Access Compliance Report

Public Rights-of-Way

(Curb Ramps)

Intersection ID: 46197	Main Street: FERNSPRAY_RD	Cross Street: SEVEN_OAKS_DR	Location: SE
ADA ID: AB798B0F4EEF	Ramp Type: PerpDiag	Initial Pass/Fail: Fail	Overall Compliance: No
Severity Score: 13.75			
Codes/Mitigation Info/Possible Solution		Field Measurements/Component Compliance

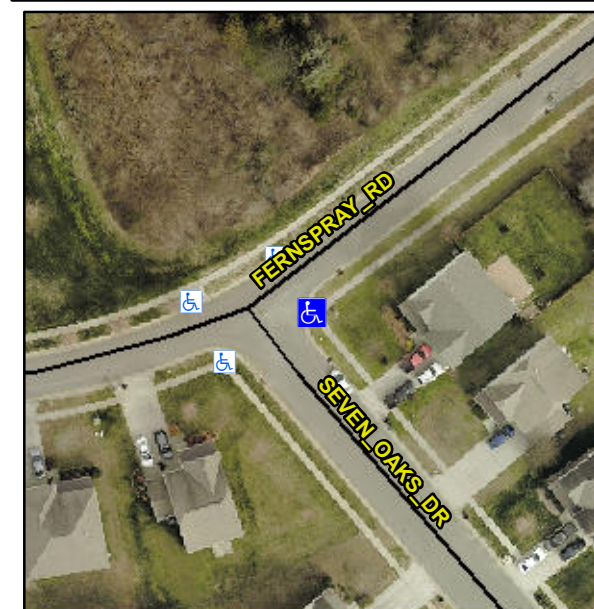
Not Found, R304.2.2, R304.5.3

Compliance	Description	Data	Compliance	Description	Data
N/A	Ramp Length (in)	68.0	No	Ramp Slope (%)	8.6
Yes	Ramp Width (in)	48.0	No	Ramp XSlope (%)	2.6
N/A	Flare Type LT	N/A	N/A	Flare Type RT	N/A
N/A	Flare Slope LT (%)	N/A	N/A	Flare Slope RT (%)	N/A
N/A	Flare Traversable LT?	N/A	N/A	Flare Traversable RT?	N/A
N/A	Landing Length (in)	N/A	N/A	DWS Provided?	N/A
N/A	Landing Width (in)	N/A	N/A	DWS Contrast?	N/A
N/A	Landing Slope (%)	N/A	N/A	DWS Length (in)	N/A
N/A	Landing X Slope (%)	N/A	N/A	DWS Full Width?	N/A
N/A	Landing Curb? (Y/N)	N/A	N/A	DWS Offset (in)	N/A
N/A	Shared Landing?	N/A			
N/A	Gutter Ponding?	N/A	N/A	Gutter Slope (%)	N/A
N/A	Gutter Lip Ht (in)	1.0	N/A	Gutter X Slope (%)	N/A
N/A	Painted X Walk1?	No	N/A	Painted X Walk2?	No
	X Walk 1 Direction	To N		X Walk 2 Direction	To W
N/A	X Walk 1 Width (in)	N/A	N/A	X Walk 2 Width (in)	N/A
	X Walk 1 Slope (%)	2.8		X Walk 2 Slope (%)	1.2
	X Walk 1 X Slope (%)	2.8		X Walk 2 X Slope (%)	0.5

N/A	Ramp inside XWalk1?	N/A	N/A	Ramp inside XWalk2?	N/A
	Road Slope (%)	0.8	N/A	Clear Space?	N/A
	Road X Slope (%)	3.2	N/A	Clear Space to XWalk (in)	N/A
N/A	Any Obstructions?	N/A	N/A	Storm Grate/Utility Hazard?	N/A
	Obstruction Type			Storm Grate/Utility Type	
		N/A			N/A
		Yes		Surface Condition? (G/P)	Good

Remove & Replace Curb Ramp With Two New Directional Ramps or Equivalent.
